Attachment 3

**Proposed Technical Specification Bases Changes (Mark-up)
(For Information Only)**

Brunswick Unit 1

SR 3.4.7.2

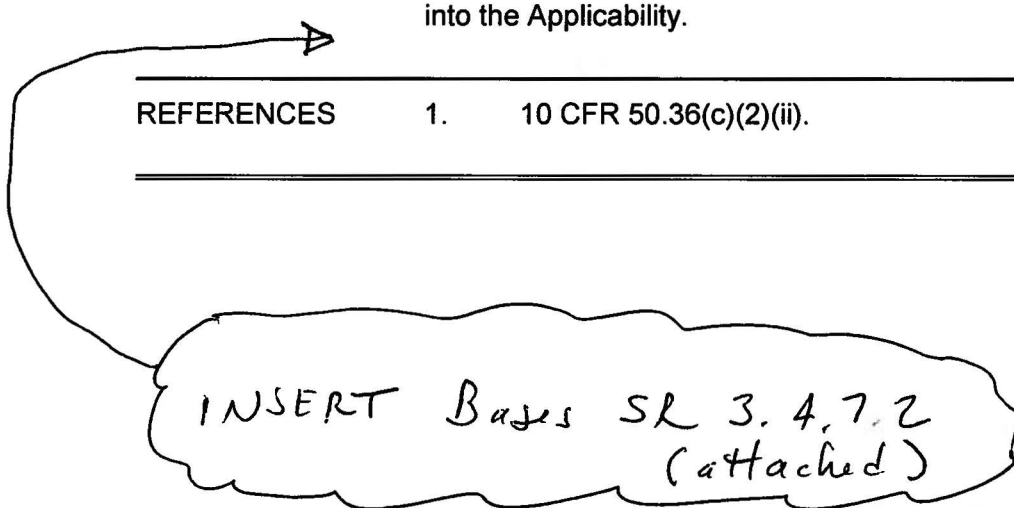
INSERT Bases SR 3.4.7.2
(attached)

RHR Shutdown Cooling System piping and components have the potential to develop voids and pockets of entrained gases. Preventing and managing gas intrusion and accumulation is necessary for proper operation of the RHR shutdown cooling subsystems and may also prevent water hammer, pump cavitation, and pumping of noncondensable gas into the reactor vessel.

Selection of RHR Shutdown Cooling System locations susceptible to gas accumulation is based on a review of system design information, including piping and instrumentation drawings, isometric drawings, plan and elevation drawings, and calculations. The design review is supplemented by system walk downs to validate the system high points and to confirm the location and orientation of important components that can become sources of gas or could otherwise cause gas to be trapped or difficult to remove during system maintenance or restoration. Susceptible locations depend on plant and system configuration, such as stand-by versus operating conditions.

The RHR Shutdown Cooling System is OPERABLE when it is sufficiently filled with water. Acceptance criteria are established for the volume of accumulated gas at susceptible locations. If accumulated gas is discovered that exceeds the acceptance criteria for the susceptible location (or the volume of accumulated gas at one or more susceptible locations exceeds an acceptance criteria for gas volume at the suction or discharge of a pump), the Surveillance is not met. If it is determined by subsequent evaluation that the RHR Shutdown Cooling System is not rendered inoperable by the accumulated gas (i.e., the system is sufficiently filled with water), the Surveillance may be declared met. Accumulated gas should be eliminated or brought within the acceptance criteria limits. If the accumulated gas is eliminated or brought within the acceptance criteria limits as part of the Surveillance performance, the Surveillance is considered met and the system is OPERABLE. Past operability is then evaluated under the Corrective Action program. If it is suspected that a gas intrusion event is occurring, then this is evaluated under the Operability Determination Process.

Gas accumulation in the RHR shutdown cooling (SDC) suction flow path is satisfactorily addressed by procedures which fill the system prior to placing SDC in service. Since the non-safety shutdown cooling mode of RHR is manually initiated at a low reactor pressure, sufficient time is available to ensure fill and warm-up of the flow path have been performed prior to starting an RHR pump, thereby avoiding any unacceptable pressure transients on the system.

RHR Shutdown Cooling System locations susceptible to gas accumulation are monitored and, if gas is found, the gas volume is compared to the acceptance criteria for the location. Susceptible locations in the same system flow path which are subject to the same gas intrusion mechanisms may be verified by monitoring a representative sub-set of susceptible locations. Monitoring may not be practical for locations that are inaccessible due to radiological or environmental conditions, the plant configuration, or personnel safety. For these locations alternative methods (e.g., operating parameters, remote monitoring) may be used to monitor the susceptible location. Monitoring is not required for susceptible locations where the maximum potential accumulated gas void volume has been evaluated and determined to not challenge system OPERABILITY. The accuracy of the method used for monitoring the susceptible locations and trending of the results should be sufficient to assure system OPERABILITY during the Surveillance interval.

This SR is modified by a Note that states the SR is not required to be performed until 12 hours after reactor steam dome pressure is less than the RHR shutdown cooling isolation pressure. In a rapid shutdown, there may be insufficient time to verify all susceptible locations prior to entering the Applicability.

The 31 day Frequency takes into consideration the gradual nature of gas accumulation in the RHR Shutdown Cooling System piping and the procedural controls governing system operation.

SR 3.4.8.2

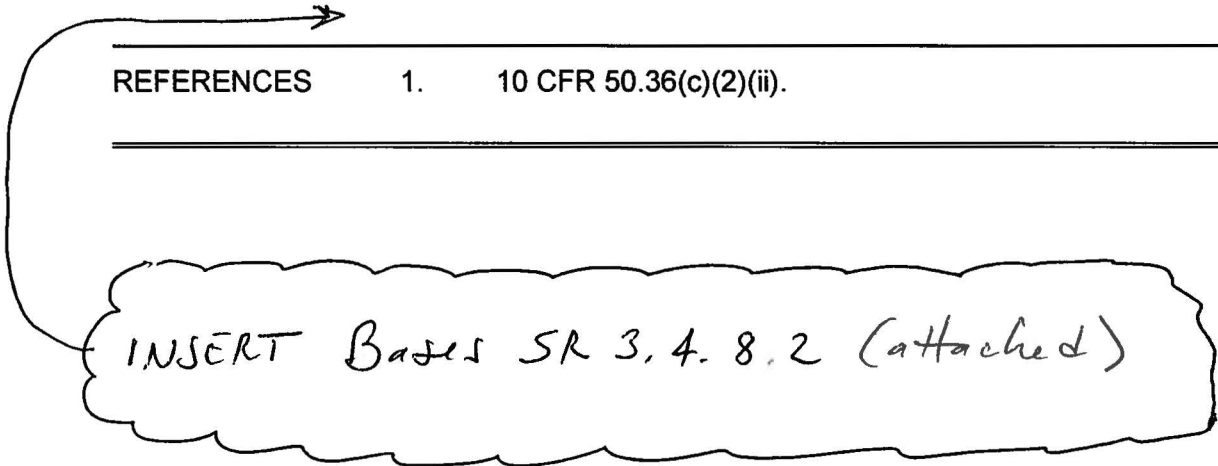
INSERT Bases SR 3.4.8.2 (attached)

RHR Shutdown Cooling System piping and components have the potential to develop voids and pockets of entrained gases. Preventing and managing gas intrusion and accumulation is necessary for proper operation of the RHR shutdown cooling subsystems and may also prevent water hammer, pump cavitation, and pumping of noncondensable gas into the reactor vessel.

Selection of RHR Shutdown Cooling System locations susceptible to gas accumulation is based on a review of system design information, including piping and instrumentation drawings, isometric drawings, plan and elevation drawings, and calculations. The design review is supplemented by system walk downs to validate the system high points and to confirm the location and orientation of important components that can become sources of gas or could otherwise cause gas to be trapped or difficult to remove during system maintenance or restoration. Susceptible locations depend on plant and system configuration, such as stand-by versus operating conditions.

The RHR Shutdown Cooling System is OPERABLE when it is sufficiently filled with water. Acceptance criteria are established for the volume of accumulated gas at susceptible locations. If accumulated gas is discovered that exceeds the acceptance criteria for the susceptible location (or the volume of accumulated gas at one or more susceptible locations exceeds an acceptance criteria for gas volume at the suction or discharge of a pump), the Surveillance is not met. If it is determined by subsequent evaluation that the RHR Shutdown Cooling System is not rendered inoperable by the accumulated gas (i.e., the system is sufficiently filled with water), the Surveillance may be declared met. Accumulated gas should be eliminated or brought within the acceptance criteria limits. If the accumulated gas is eliminated or brought within the acceptance criteria limits as part of the Surveillance performance, the Surveillance is considered met and the system is OPERABLE. Past operability is then evaluated under the Corrective Action program. If it is suspected that a gas intrusion event is occurring, then this is evaluated under the Operability Determination Process.

Gas accumulation in the RHR shutdown cooling (SDC) suction flow path is satisfactorily addressed by procedures which fill the system prior to placing SDC in service. Since the non-safety shutdown cooling mode of RHR is manually initiated at a low reactor pressure, sufficient time is available to ensure fill and warm-up of the flow path have been performed prior to starting an RHR pump, thereby avoiding any unacceptable pressure transients on the system.

RHR Shutdown Cooling System locations susceptible to gas accumulation are monitored and, if gas is found, the gas volume is compared to the acceptance criteria for the location. Susceptible locations in the same system flow path which are subject to the same gas intrusion mechanisms may be verified by monitoring a representative sub-set of susceptible locations. Monitoring may not be practical for locations that are inaccessible due to radiological or environmental conditions, the plant configuration, or personnel safety. For these locations alternative methods (e.g., operating parameters, remote monitoring) may be used to monitor the susceptible location. Monitoring is not required for susceptible locations where the maximum potential accumulated gas void volume has been evaluated and determined to not challenge system OPERABILITY. The accuracy of the method used for monitoring the susceptible locations and trending of the results should be sufficient to assure system OPERABILITY during the Surveillance interval.

The 31 day Frequency takes into consideration the gradual nature of gas accumulation in the RHR Shutdown Cooling System piping and the procedural controls governing system operation.

INSERT Bases SR 3.6.2.3.3
(attached)

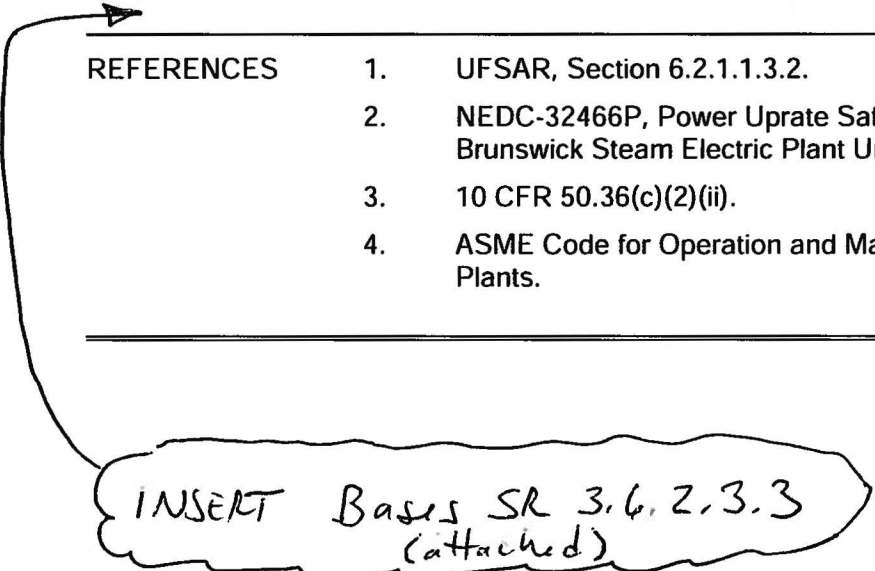
Selection of RHR Suppression Pool Cooling System locations susceptible to gas accumulation is based on a review of system design information, including piping and instrumentation drawings, isometric drawings, plan and elevation drawings, and calculations. The design review is supplemented by system walk downs to validate the system high points and to confirm the location and orientation of important components that can become sources of gas or could otherwise cause gas to be trapped or difficult to remove during system maintenance or restoration. Susceptible locations depend on plant and system configuration, such as stand-by versus operating conditions.

RHR Suppression Pool Cooling System locations susceptible to gas accumulation are monitored and, if gas is found, the gas volume is compared to the acceptance criteria for the location. Susceptible locations in the same system flow path which are subject to the same gas intrusion mechanisms may be verified by monitoring a representative sub-set of susceptible locations. Monitoring may not be practical for locations that are inaccessible due to radiological or environmental conditions, the plant configuration, or personnel safety. For these locations alternative methods (e.g., operating parameters, remote monitoring) may be used to monitor the susceptible location. Monitoring is not required for susceptible locations where the maximum potential accumulated gas void volume has been evaluated and determined to not challenge system OPERABILITY. The accuracy of the method used for monitoring the susceptible locations and trending of the results should be sufficient to assure system OPERABILITY during the Surveillance interval.

INSERT Bases SR 3.4.7.2
(attached)

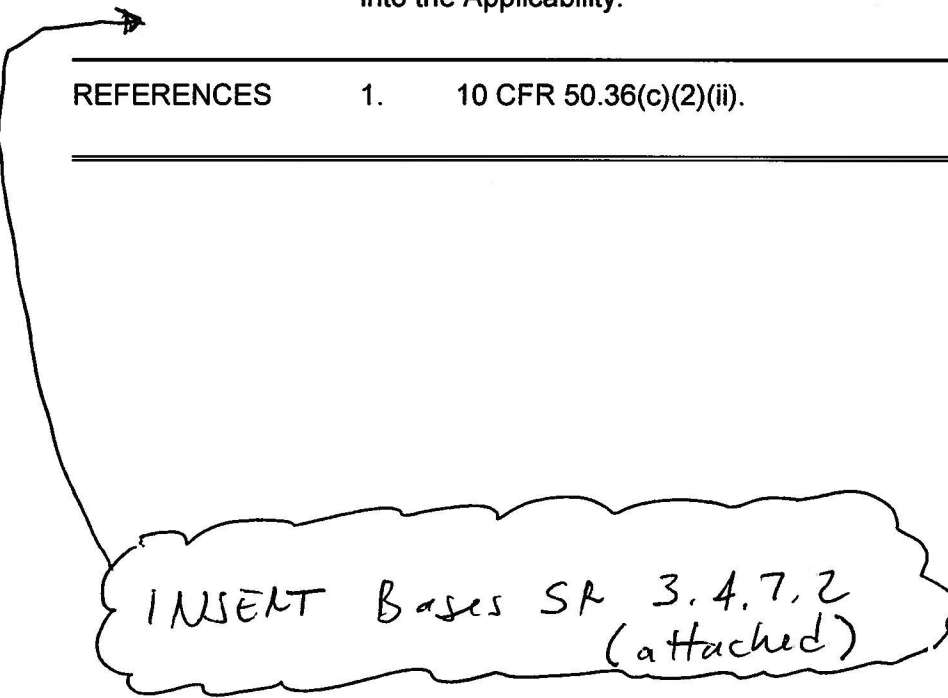
Selection of RHR Shutdown Cooling System locations susceptible to gas accumulation is based on a review of system design information, including piping and instrumentation drawings, isometric drawings, plan and elevation drawings, and calculations. The design review is supplemented by system walk downs to validate the system high points and to confirm the location and orientation of important components that can become sources of gas or could otherwise cause gas to be trapped or difficult to remove during system maintenance or restoration. Susceptible locations depend on plant and system configuration, such as stand-by versus operating conditions.

RHR Shutdown Cooling System locations susceptible to gas accumulation are monitored and, if gas is found, the gas volume is compared to the acceptance criteria for the location. Susceptible locations in the same system flow path which are subject to the same gas intrusion mechanisms may be verified by monitoring a representative sub-set of susceptible locations. Monitoring may not be practical for locations that are inaccessible due to radiological or environmental conditions, the plant configuration, or personnel safety. For these locations alternative methods (e.g., operating parameters, remote monitoring) may be used to monitor the susceptible location. Monitoring is not required for susceptible locations where the maximum potential accumulated gas void volume has been evaluated and determined to not challenge system OPERABILITY. The accuracy of the method used for monitoring the susceptible locations and trending of the results should be sufficient to assure system OPERABILITY during the Surveillance interval.

This SR is modified by a Note that states the SR is not required to be performed until 12 hours after reactor steam dome pressure is less than the RHR shutdown cooling isolation pressure. In a rapid shutdown, there may be insufficient time to verify all susceptible locations prior to entering the Applicability.
